City of Santa Fe, New Mexico

memo

2025-011724-HDRB, 210 Don Gaspar Ave., Downtown & Eastside Historic District, Significant, Martinez Architecture Studio, agent for Heritage Hotels and Resorts Inc., owner, proposes to relocate a door on a primary façade and extend a stair landing. An exception is requested to 14-5.2 (D)(5)(a) to alter a primary facade.

Figure 3: Area of Work on South Elevation

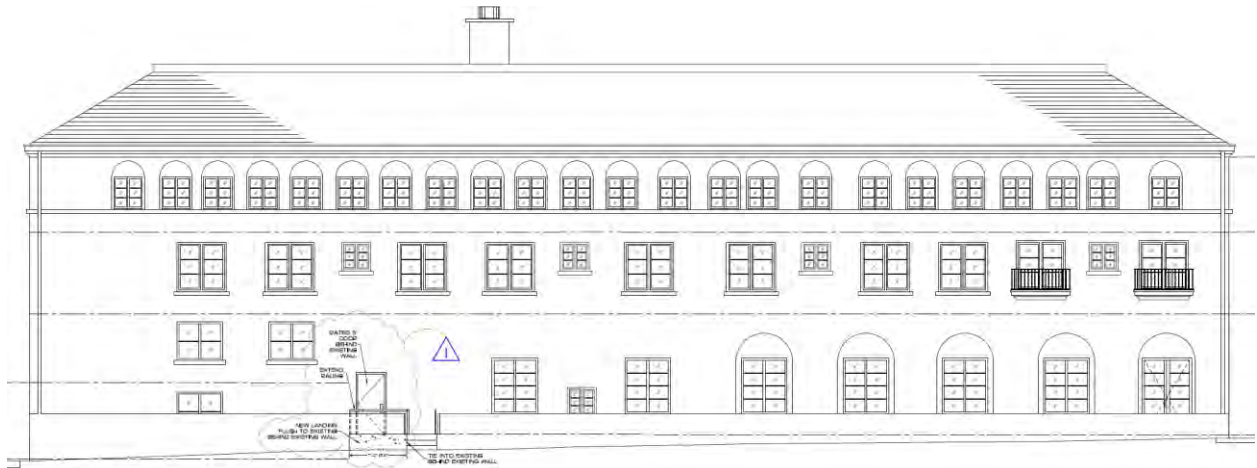
- 1) Relocate a pedestrian door on the south ground floor level of the hotel.
- 2) Extend the landing at the doorway.
- 3) Install railing at the landing.
- 4) Stucco repair to match the existing stucco.

Exception to 14-5.2(D)(5)(a): The applicant requests an exception to close an existing opening and create a new opening on the primary façade of a significant structure.

Staff Response: Staff finds that this criterion is met. The door is being moved a minimal amount, still matches the alignment and layout of windows and doors, and will still meet egress requirements for the building and provide for more accessible rooms to be available in the hotel.

Staff Response: Staff finds that this criterion is met. The door relocation is to accommodate an interior ADA accessible restroom as required for ADA-accessible rooms. The relocation will still access the same hall and is a minimal relocation of only a few feet.

Staff finds that the exception criteria have been met and recommends approval of the exception to section 14-5.2(D)(5)(a) to alter the openings on a primary façade. Staff also recommends approval of the other elements of the application as they comply with 14-5.2(D) General Design Standards for all Historic Districts, and 14-5.2(E) Downtown and Eastside Historic District Design Standards.
